Re: Proposed Preliminary Site Plan For 5216 Seminary Road

ARGUMENTS AGAINST PROPOSED PRELIMINARY SPECIAL USE PLAN

Opposition To Plan For 7 Large Townhouses For 5216 Seminary Road

RB ZONE BY-RIGHT SITE PLAN EXHIBIT 5216 SEMINARY ROAD CITY OF ALEXANDRIA, VIRGINIA

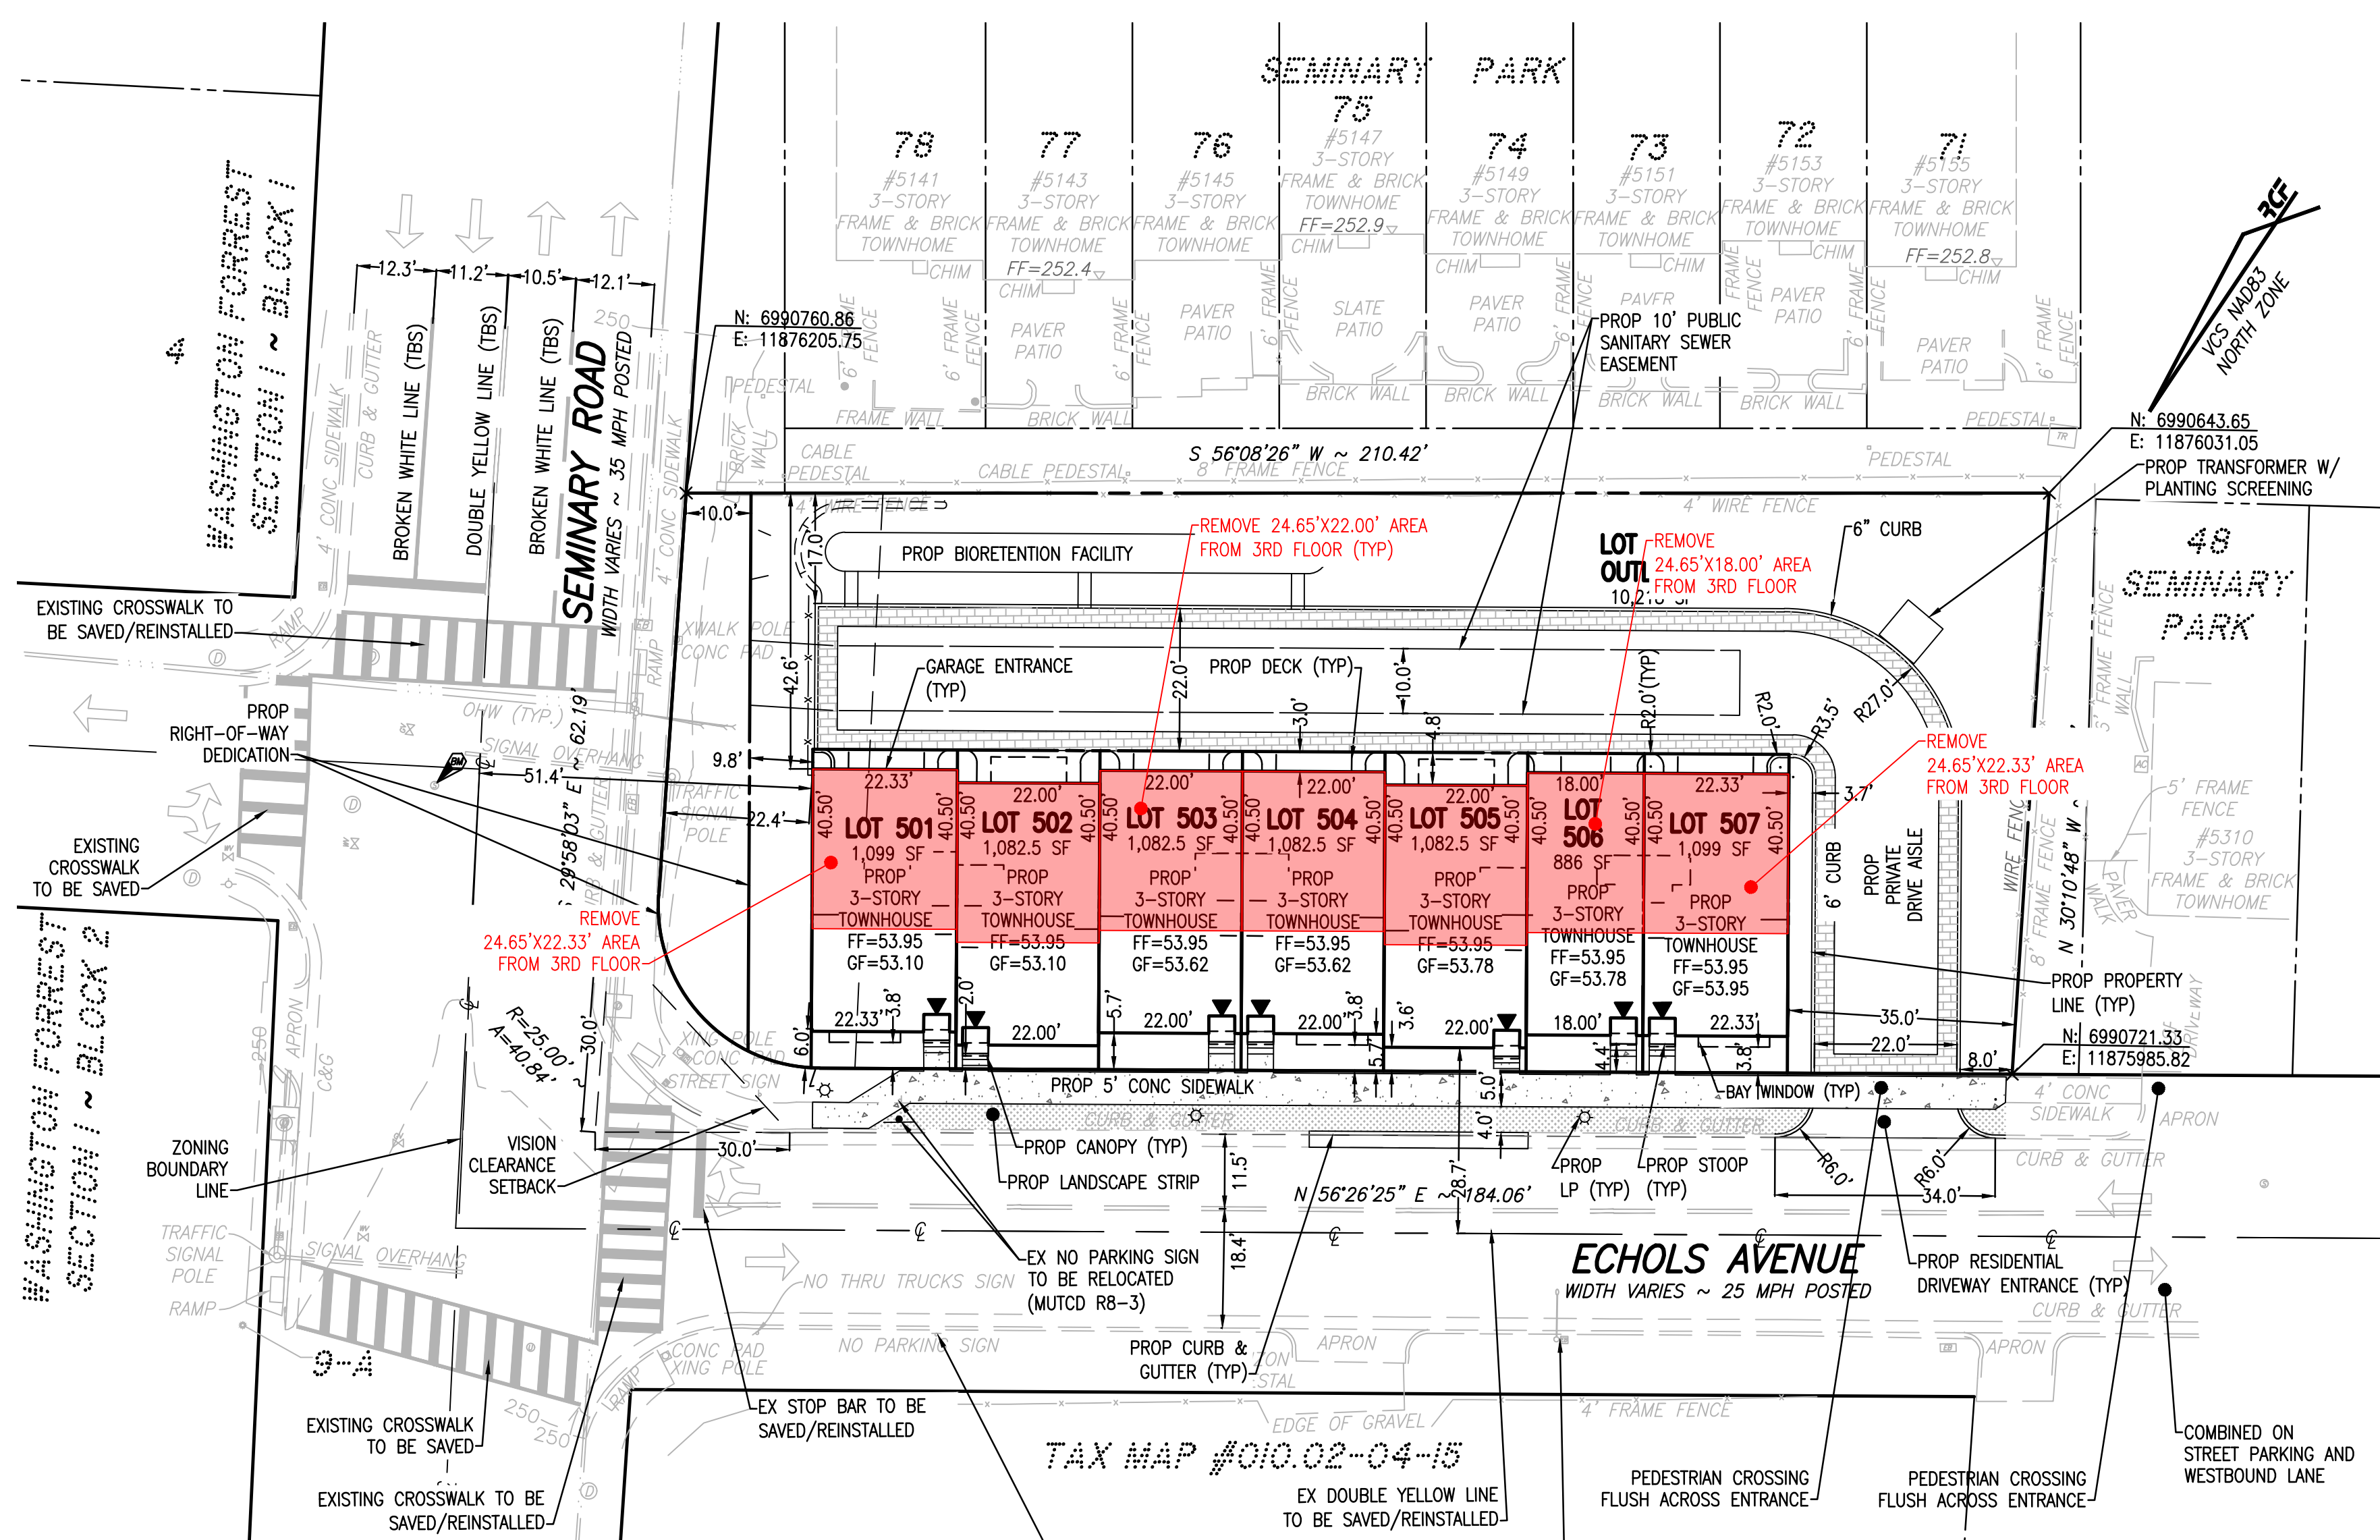
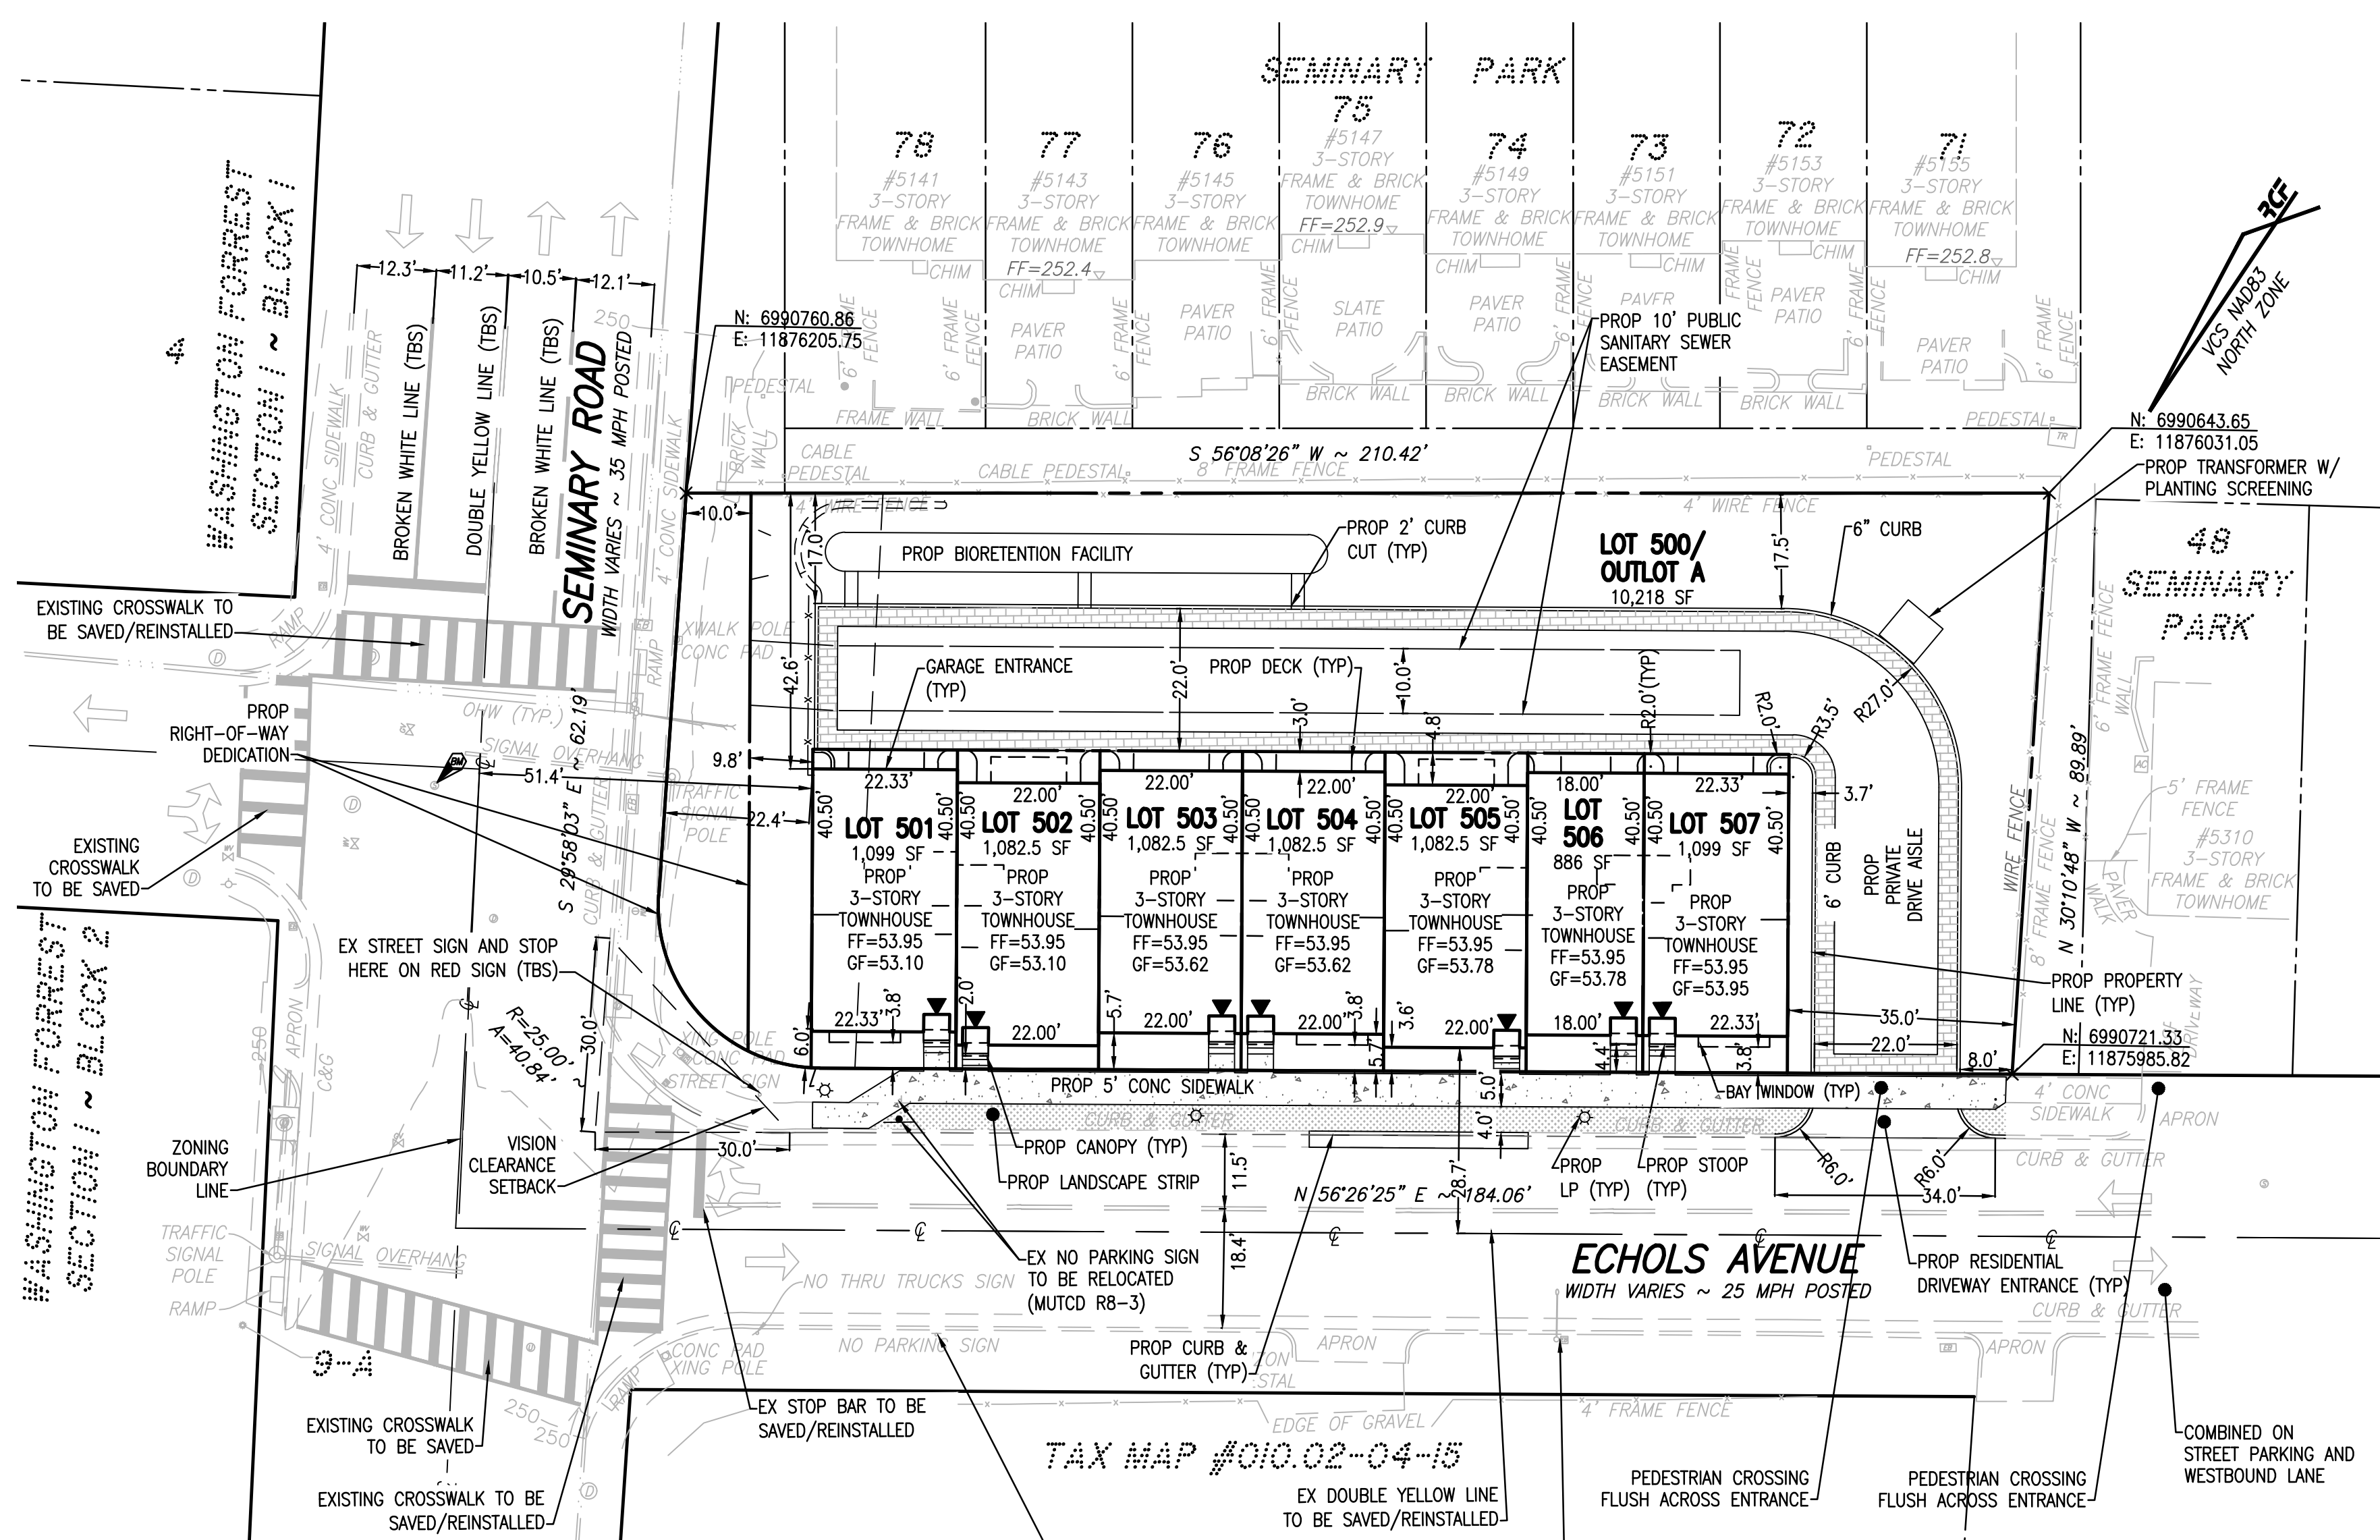
The Applicant Seeks At Least The Following Modifications From RB Zoning Rules

- Across the Board Modifications for Lots 501-507
 - Modify Echols front yard from 20ft to 3.6 ft to 5.7 ft
 - Modify minimum lot size from 1,980 SF to 866 SF to 1,099 SF

- Modify requirement that 35% of a given lot area open and usable space
- Additional Modifications Corner Lot 501
 - Exception from 60 ft set back requirement from midline of Seminary Road to 51 feet (What is authority and process?)
